**INSTRUCTION TO SERVICE ITS: 4259**

**OBJECTIVE/SUBJECT:**  
Install honeycomb material on driveshaft access door.

**Figure 1: Honeycomb assembly.**

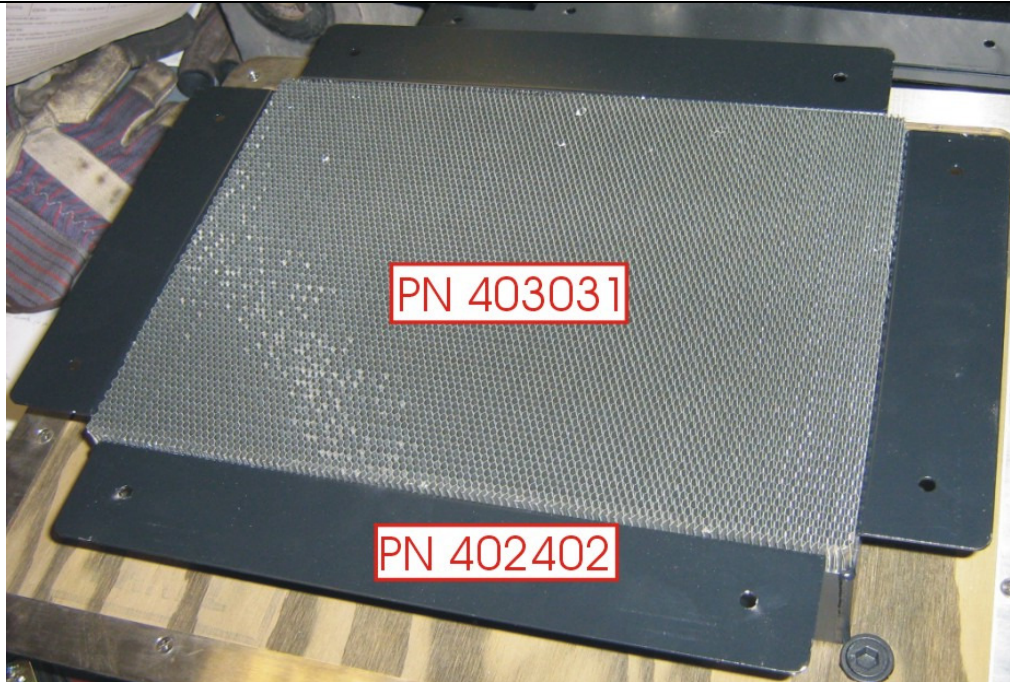
- PROCEDURE:**
1. Turn the main battery disconnect switch to the "OFF" position.
  2. Remove the driveshaft access door from the coach and place underside facing up on a work bench.
  3. Clean off loose debris on the underside of driveshaft access door.
  4. Place aluminum honeycomb (PN 403031) in aluminum enclosure (PN 402402) if not already done. See Figure 1.
